**ALLEN & MAJOR
ASSOCIATES, INC.**

DRAINAGE REPORT

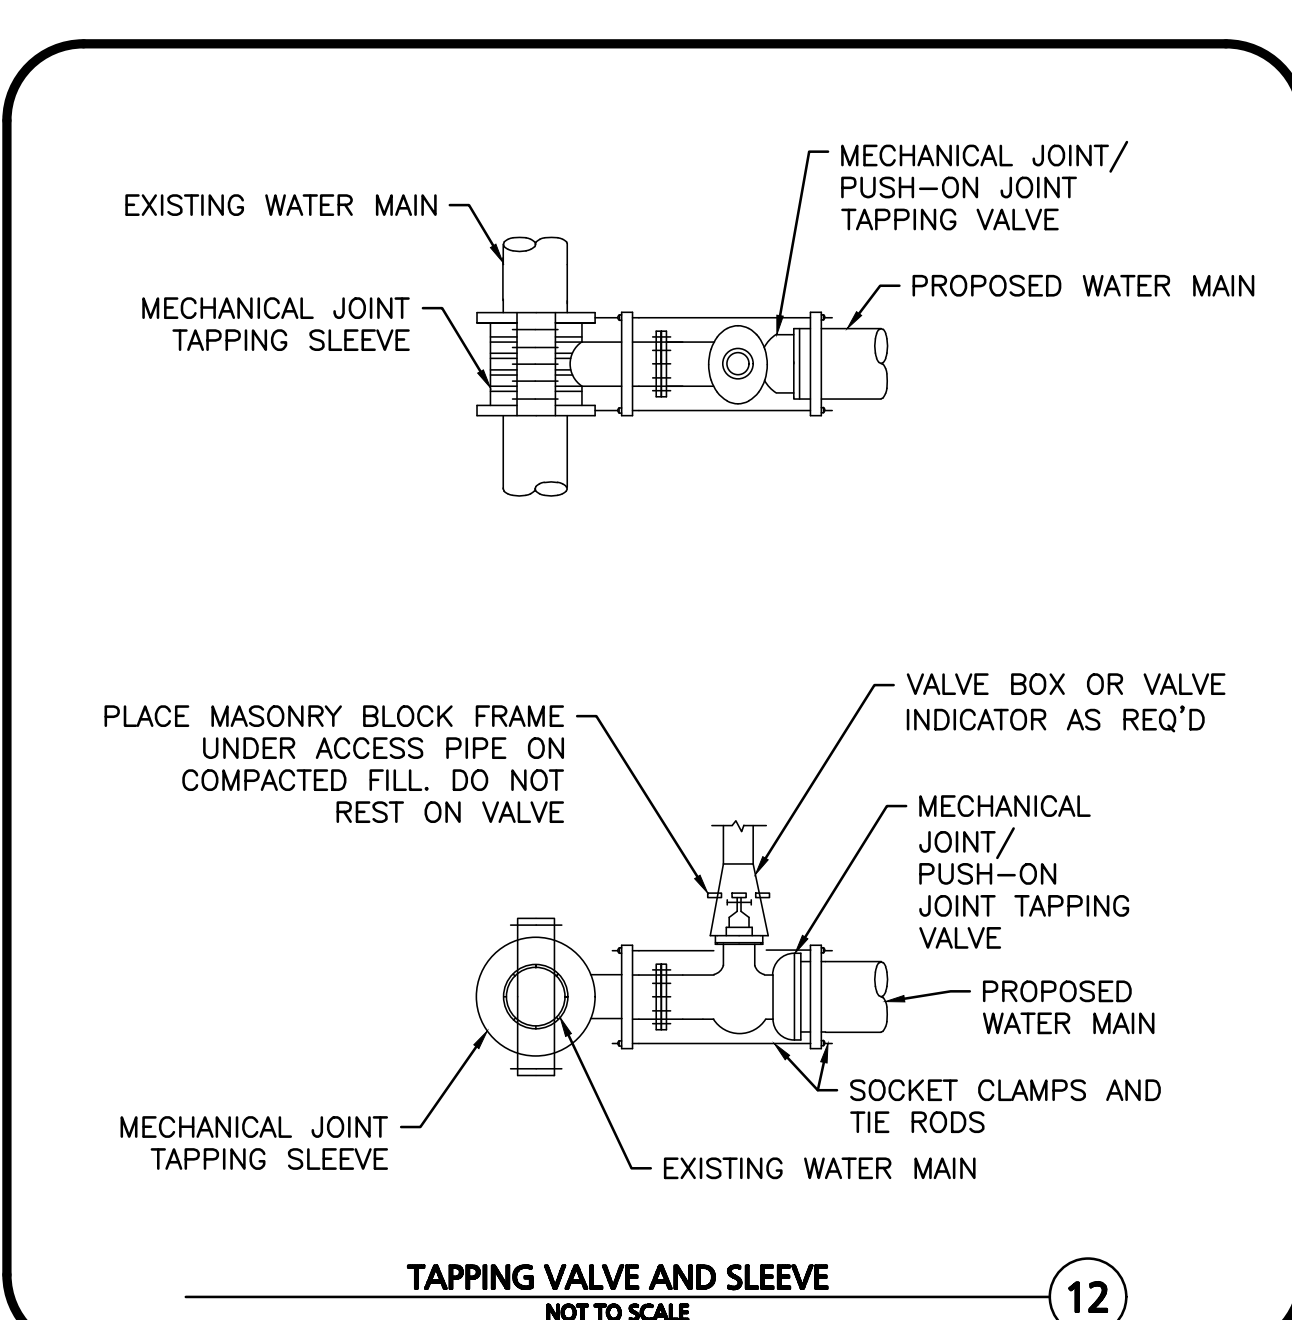
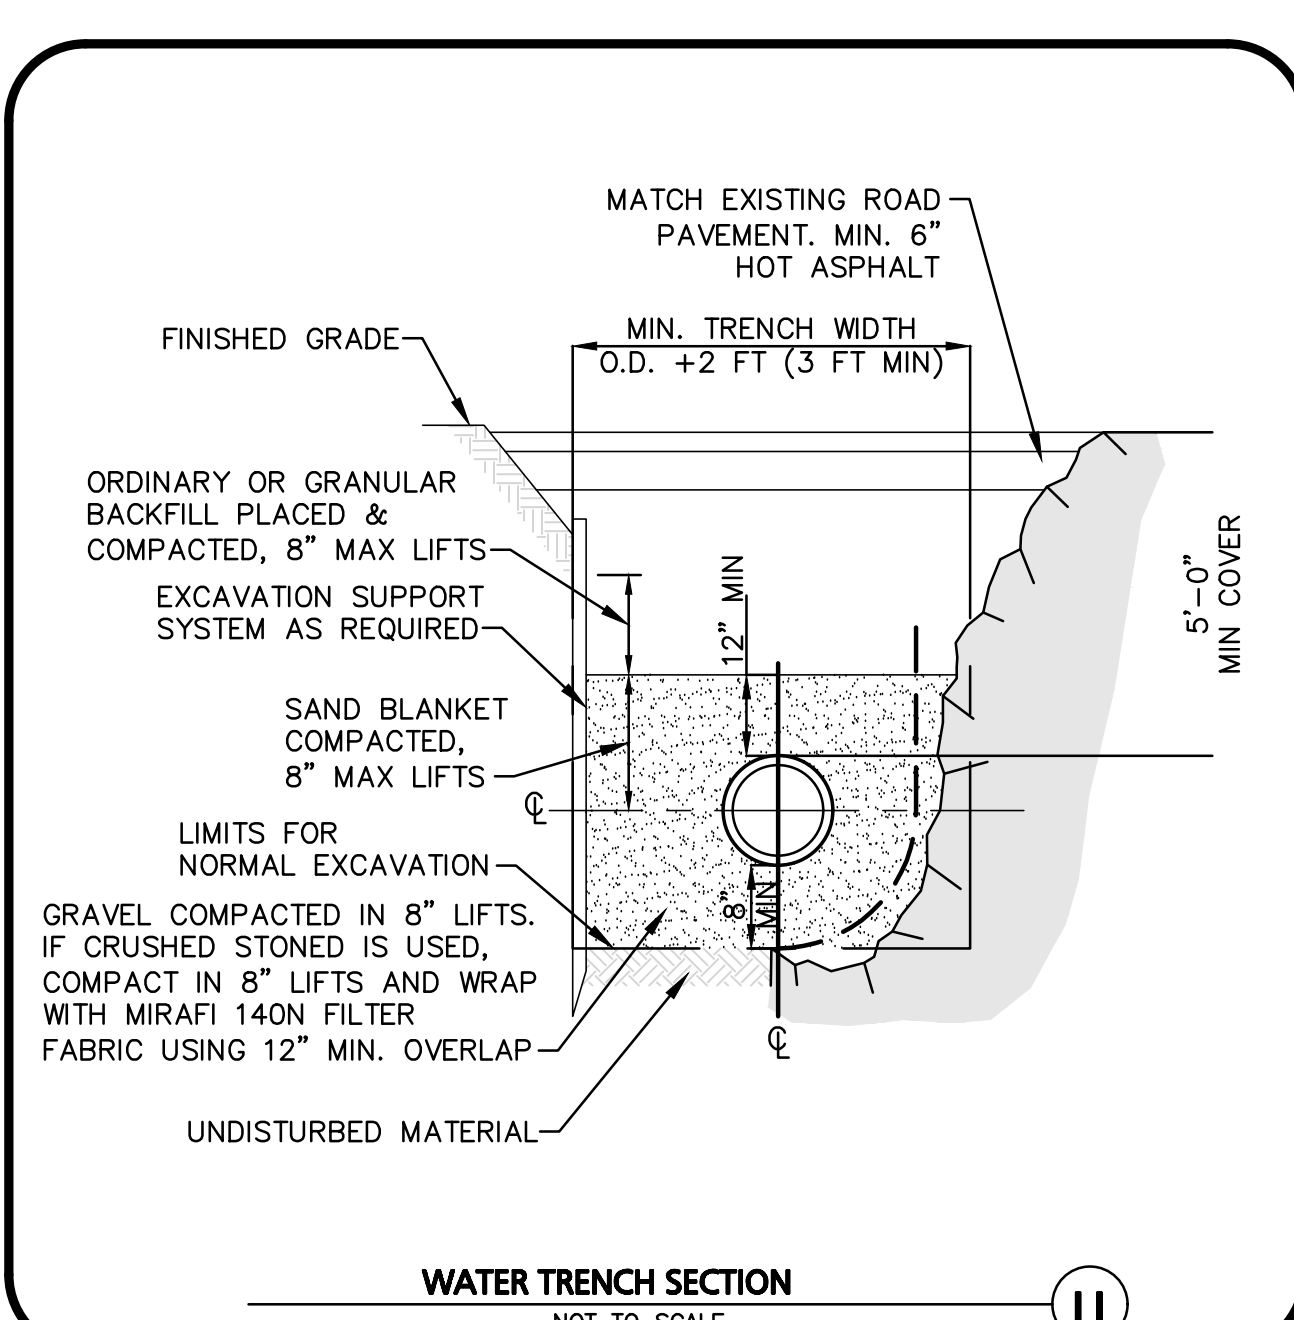
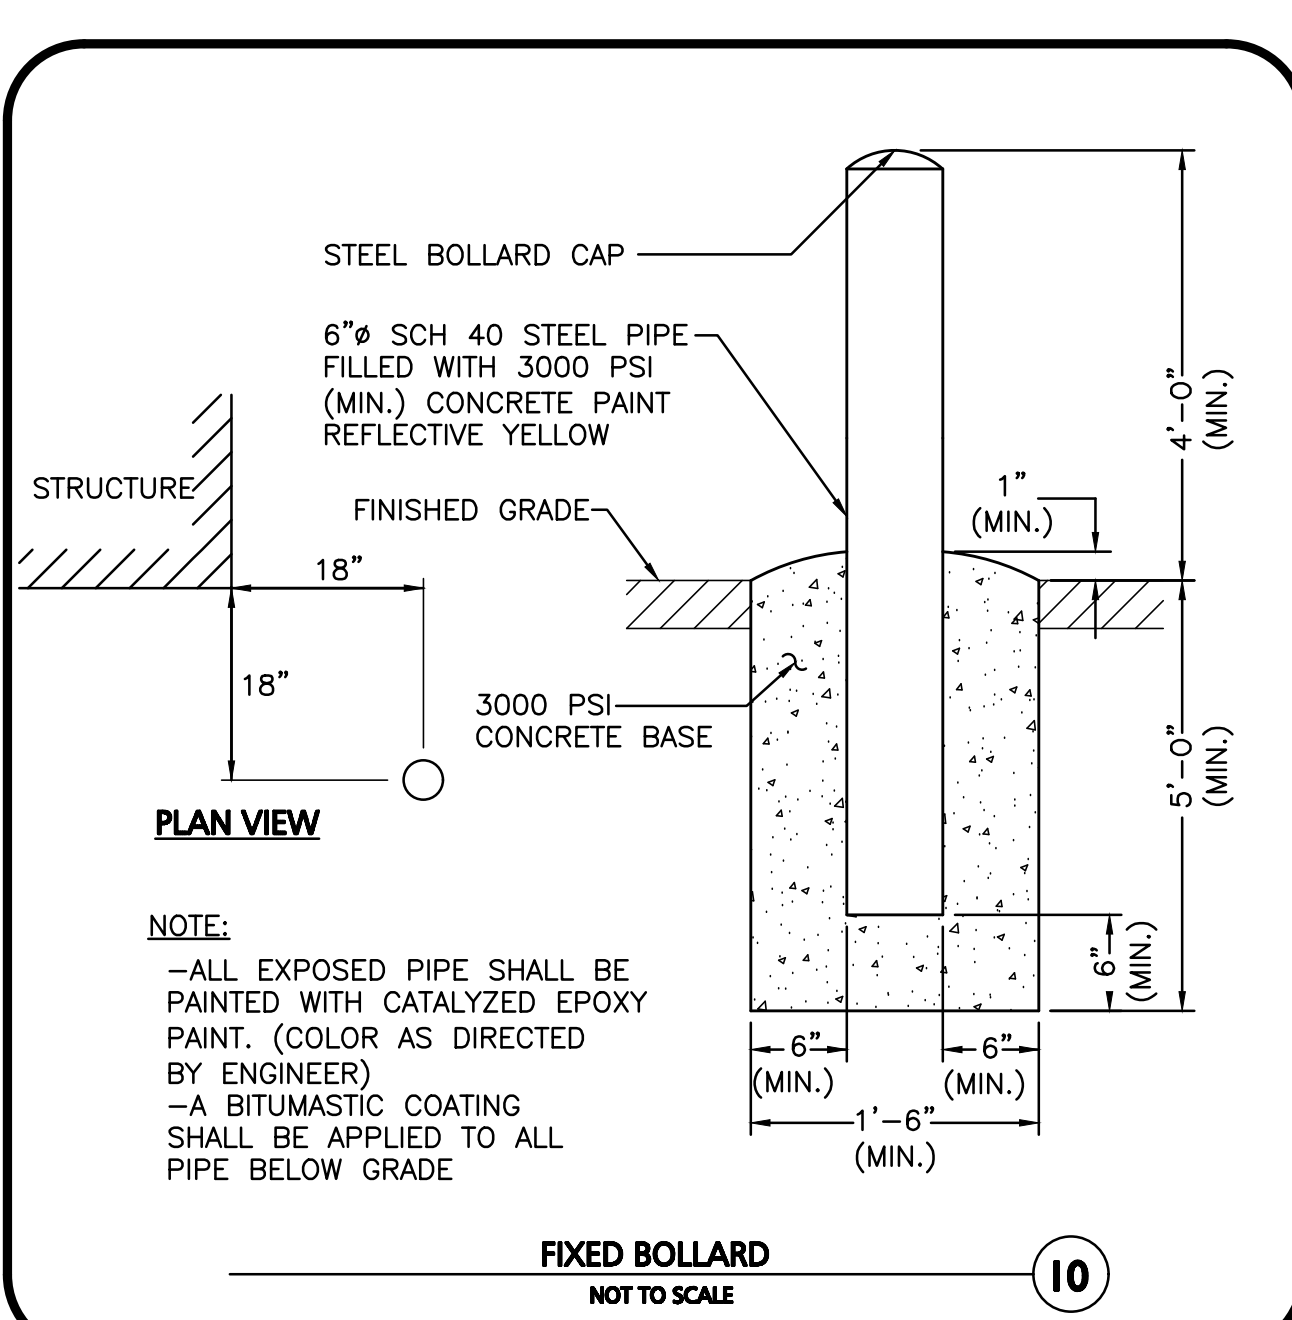
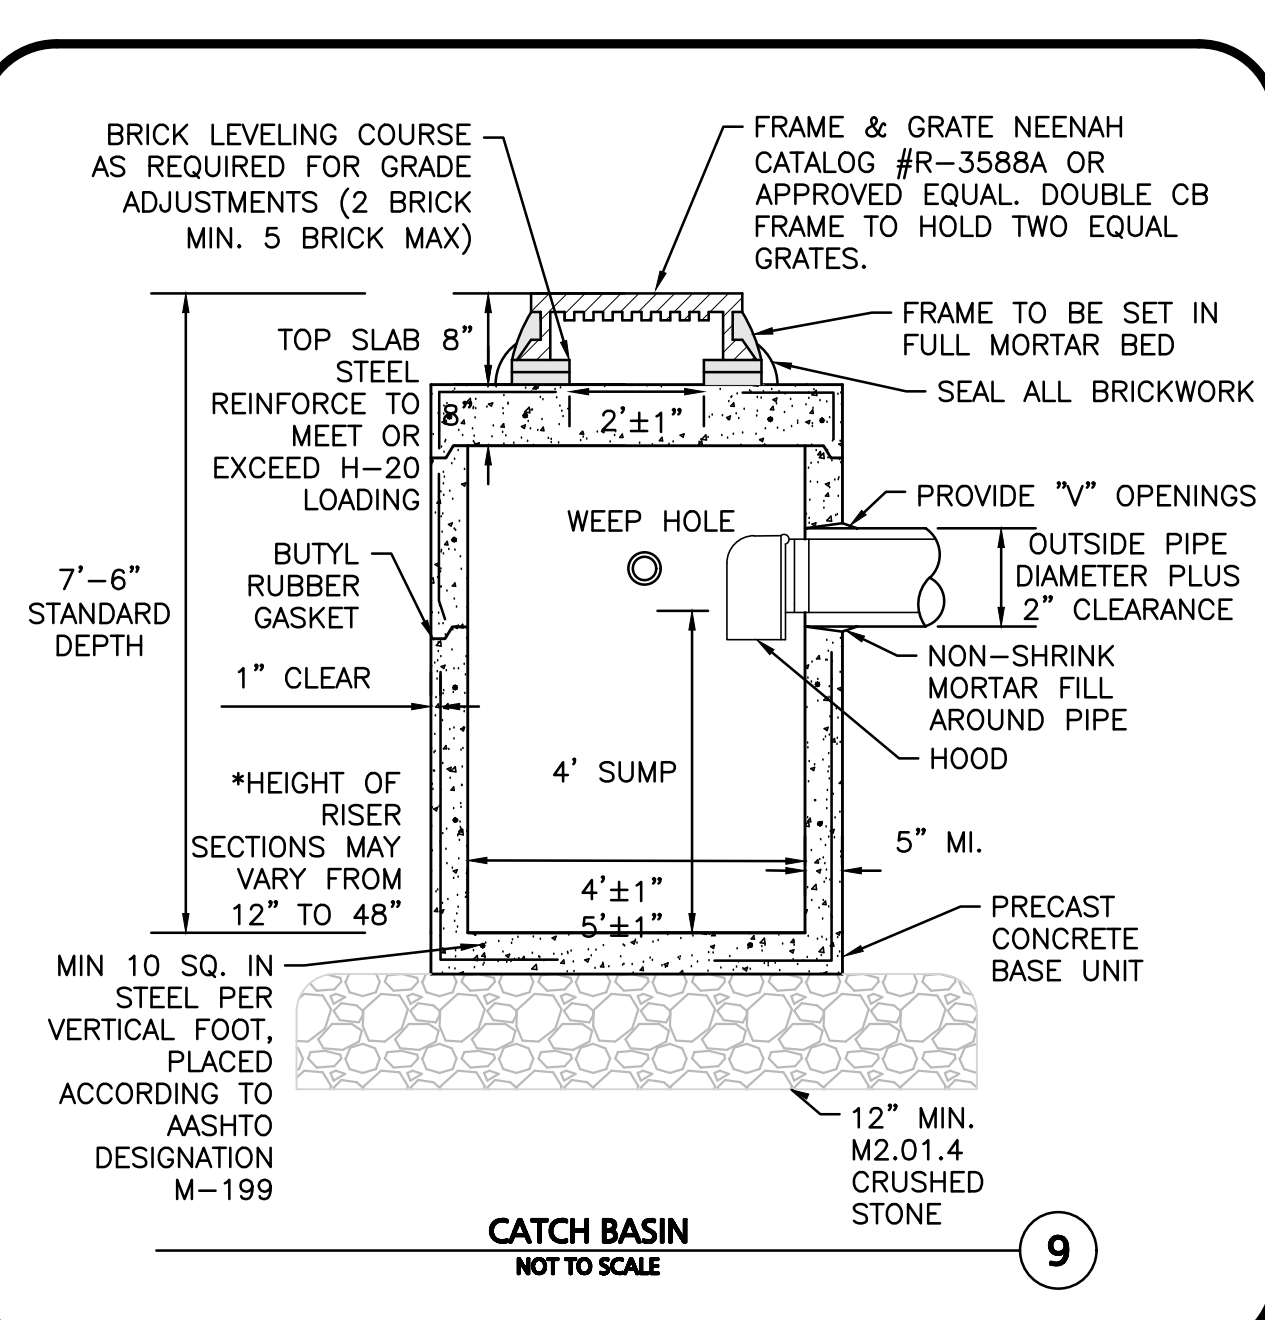
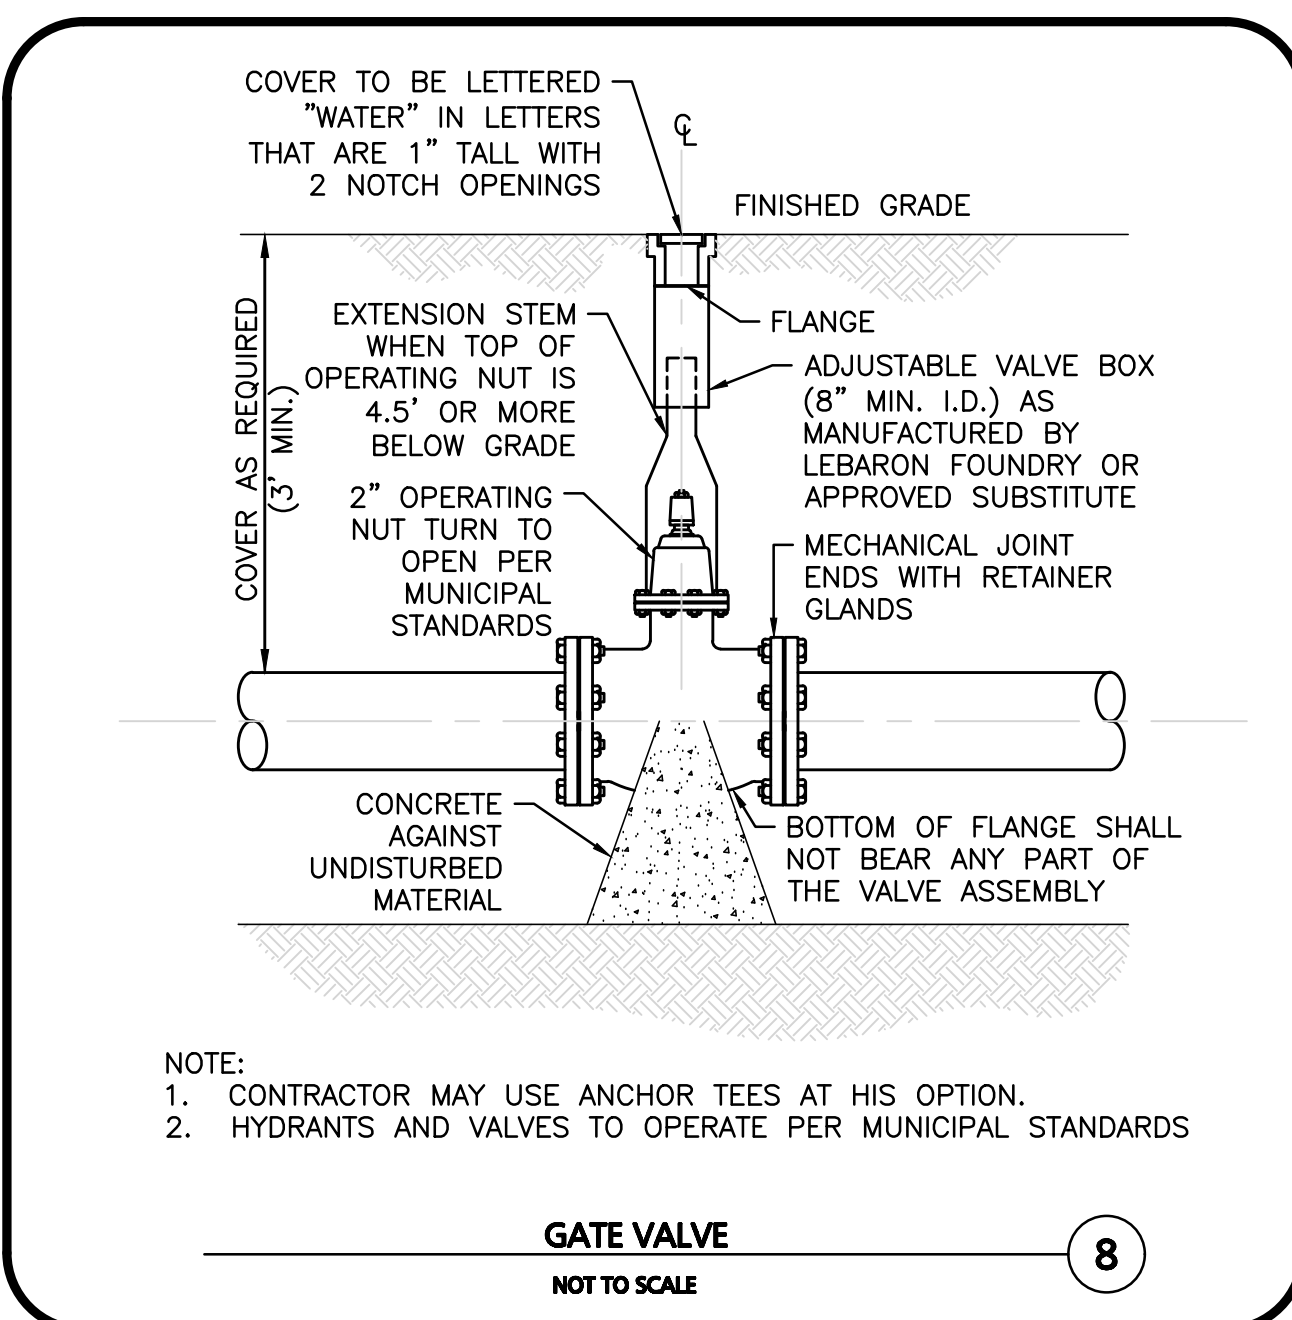
REV	DATE	DESCRIPTION
B	3/25/2024	REVISED PER TOWN COMMENTS
A	2/29/2024	REVISED PER TOWN COMMENTS
